# SERVICETEKNOTES

TABLE OF CONTENTS

Fig. 1: Strobed Hard Copy Board Timing Diagram

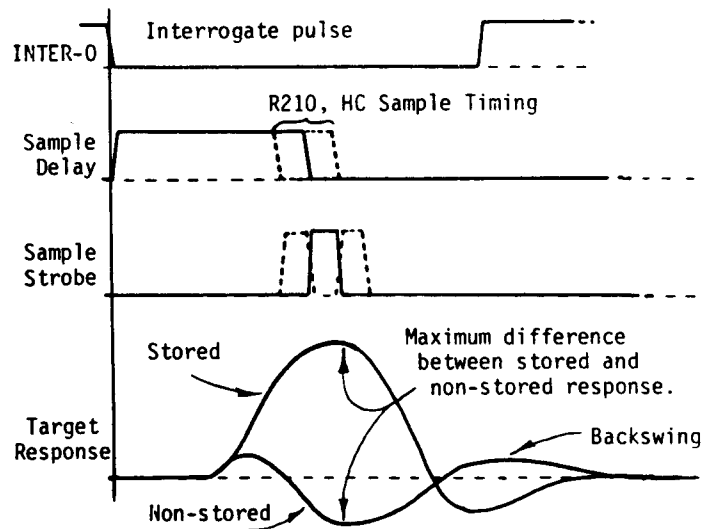
A new hard copy amplifier board is being used in the GMA101A, GMA102A, 618, 4054, and 4114. This new board, part number 670-7550-00, is identical to that now used in the GMA103, 4054 Option 31, and 4114 Option 31 products. It requires the use of the INTER-0 signal present at the backpanel hard copy connector, therefore the hard copy connector cable assembly is also changed. The addition of a potentiometer (R210, sample timing) requires that the plastic hard copy amplifier cover be changed as well.

The new board "reads" the CRT target only when a target response is most expected. This reduces the noise produced in the hard copy, especially with CRT targets exhibiting substantial backswing (see the timing diagram). The strobe window can be adjusted with R210, hard copy sample timing. Typically, R210 can be set to midrange and forgotten. Noisy copies may be improved by straying from midrange either clockwise or counterclockwise.

Figure 2

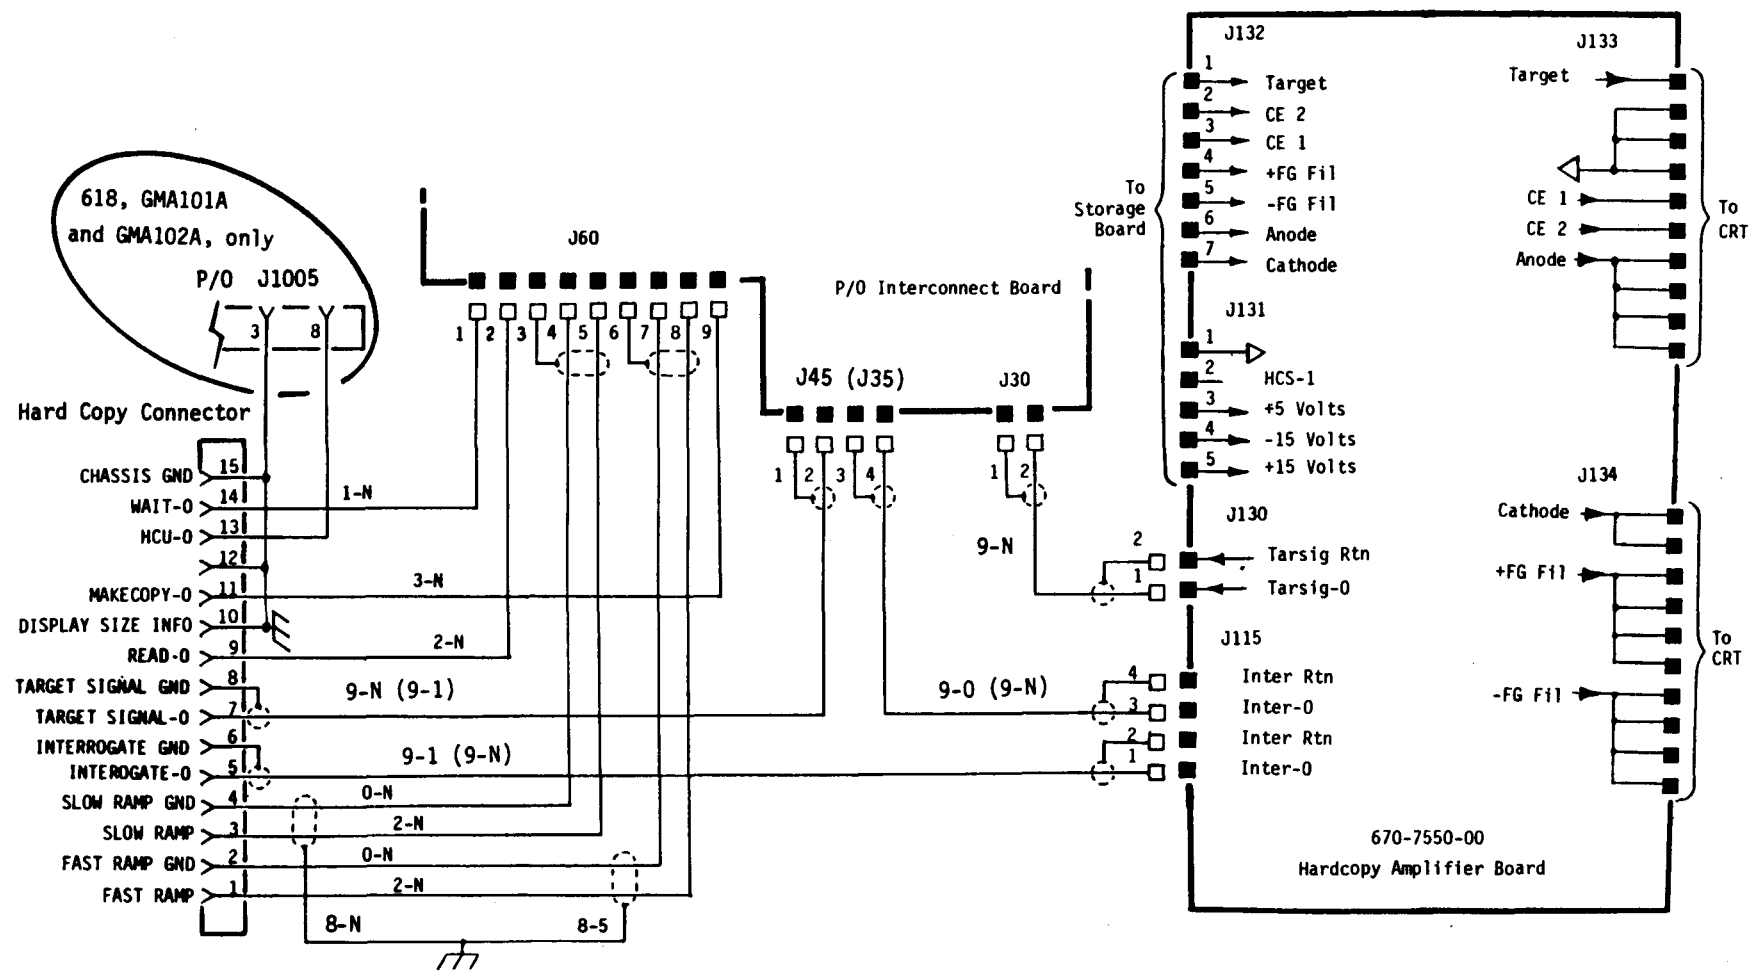
Schematics of the new board and hard copy cable assemblies are given in Figures 2 and 3. Note that the added circuits around U215 (sample timing delay) and U115 (sample strobe) distinguish this board from the earlier 670-3097-XX hard copy board. Note also that the INTER-0 signal produced by the hard copy unit is routed directly to the hard copy board to trigger the strobe. The HCS-1 signal produced on the storage board and necessary with the earlier 670-3097-0X is no longer used.

A38 —Optical Pulse Generator circuit board.

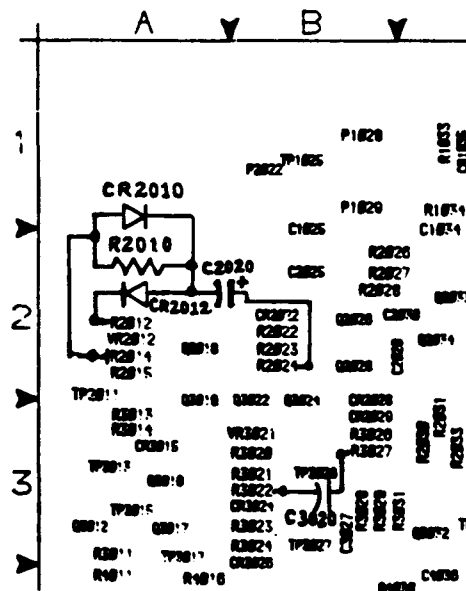
1. To top of Optical Pulse Generator Circuit Board Assy 670-7153-00, add a 15 uf capacitor (C2020) with the positive lead at the +5V end of a 100K resistor (R2024). Connect the negative lead of C2020 to the anode lead of an added diode (CR2012) and connect cathode lead of diode (CR2012) to junction of 12K resistor (R2012) and the emitter of transistor Q2018.

Connect an added diode (CR2010) and added 100K resistor (R2010) in parallel and connect the cathode end of pair at the junction of the negative lead of 15 uf capacitor (C2020) and anode lead of diode (CR2012).

Connect the anode lead of diode (CR2010), which is paralleled with resistor R2010, to the ground lead of a 100K resistor (R2014).

2. On back of the same circuit board assembly, add a .1 uf capacitor (C3020) between junction of a 360Ω resistor (R3022) and a 1.37K resistor (R3024) and the ground lead of a 20K resistor (R3027).

The above parts are located on the A38 Optical Pulse Generator board and shown on diagram 2 OPTICAL PULSE GENERATOR.

FL7705 is added as shown in partial diagram 18

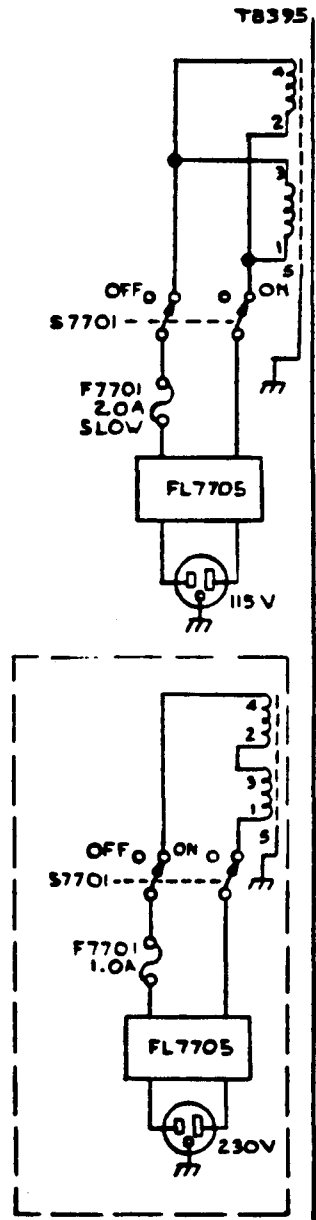
A17	670-1606-05	CKT BOARD ASSY:LV & HV POWER
CR8340	152-0750-00	SEMICOND DEVICE: RECT, SI, 600V, 3A
CR8360	152-0750-00	SEMICOND DEVICE: RECT, SI, 600V, 3A
CR8380	152-0750-00	SEMICOND DEVICE: RECT, SI, 600V, 3A

FL7705	119-1536-00	FILTER,RFI: 3A, 250 VAC, 50/60HZ
--------	-------------	----------------------------------

FL7705 is added as shown in partial diagram 16

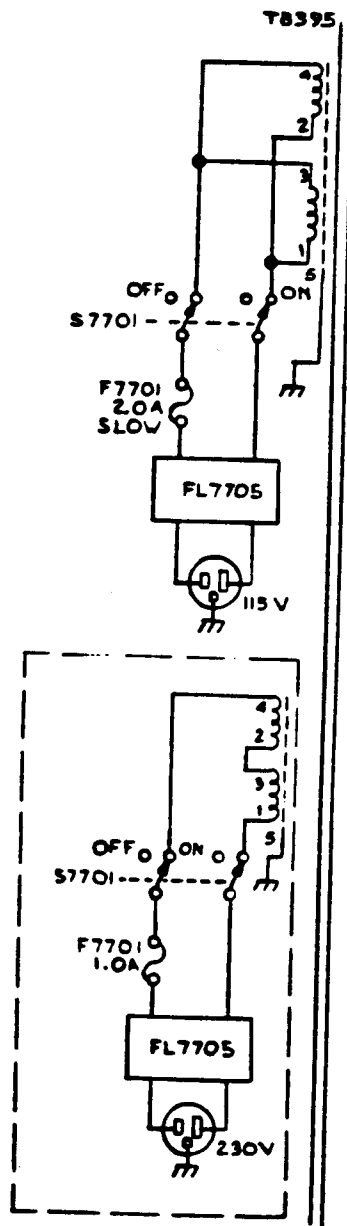
A12	670-1606-05	CKT BOARD ASSY:LV & HV POWER (650HR, 651HR, 652HR, 655HR ONLY)
A12CR8340	152-0750-00	SEMICOND DEVICE: RECT, SI, 600V, 3A
A12CR8360	152-0750-00	SEMICOND DEVICE: RECT, SI, 600V, 3A
A12CR8380	152-0750-00	SEMICOND DEVICE: RECT, SI, 600V, 3A

FL7705	119-1536-00	FILTER,RFI: 3A, 250 VAC, 50/60HZ
--------	-------------	----------------------------------

Figure 1

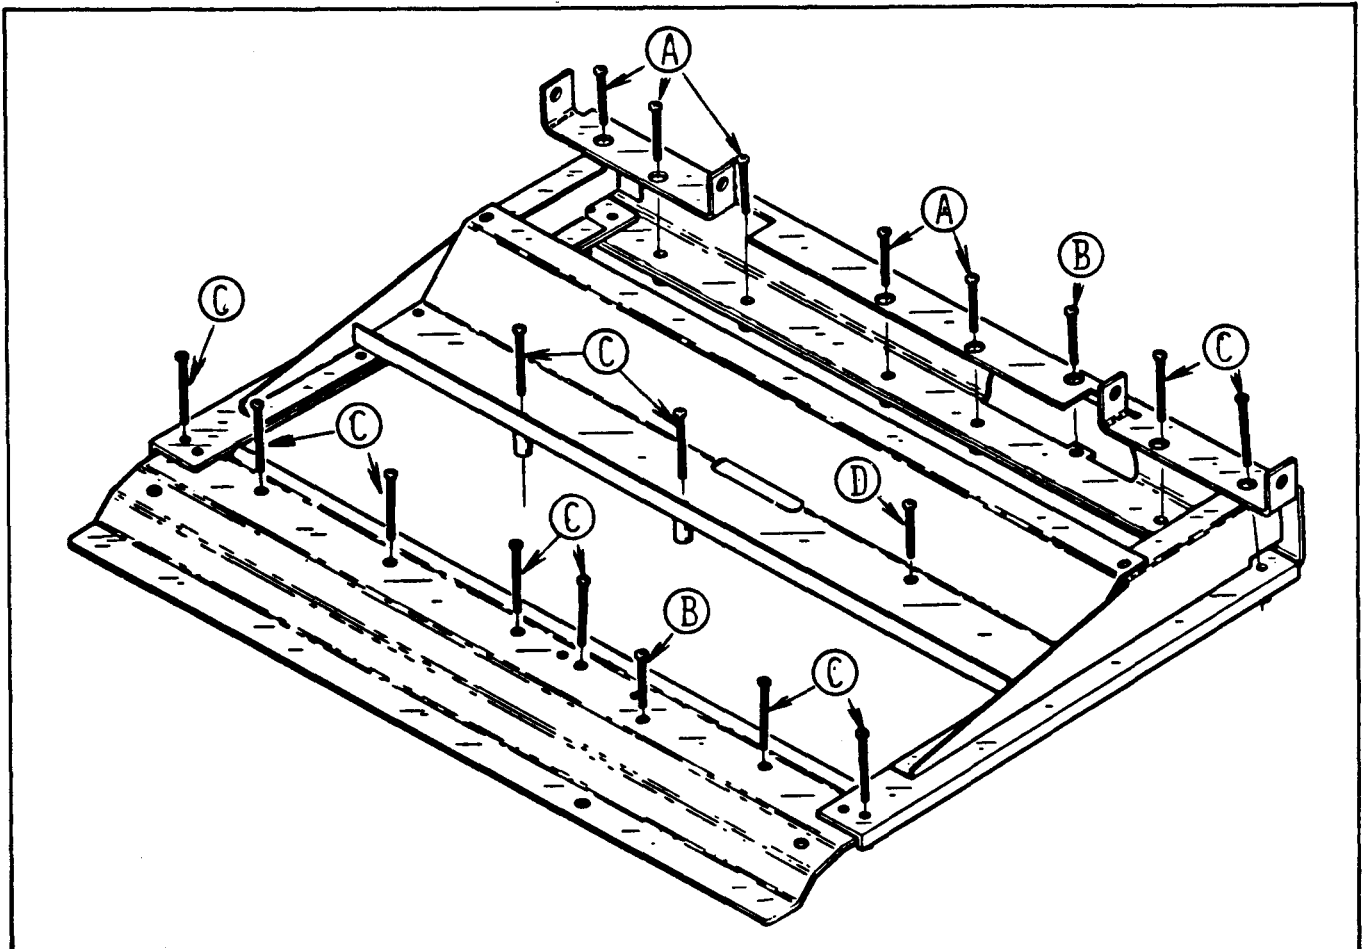
Questions have filtered in from different field personnel concerning the length and placement of the screws which hold the CPU sandwich to its frame assembly. The figure below shows the frame assembly, the screws and the holes which the screws are inserted through. Note circled alpha characters, each denote a different length screw. Following the figure is a table for cross-referencing the index character to screw length.

Note that there are two "D" type screws listed. On the 4054A this screw goes through the ALU board and into the I/O board, whereas on the 4054 it only screws to the ALU board.

<u>Index Character</u>	<u>Screw Length</u>	<u>Tektronix P/N</u>	<u>Quantity</u>	<u>Comments</u>
A	1.375"	211-0525-00	5	4054/54A
B	1.0"	211-0517-00	2	4054/54A
C	1.5"	211-0553-00	11	4054/54A
D	0.375"	211-0559-00	1	4054 only
D	1.750"	211-0530-00	1	4054A only
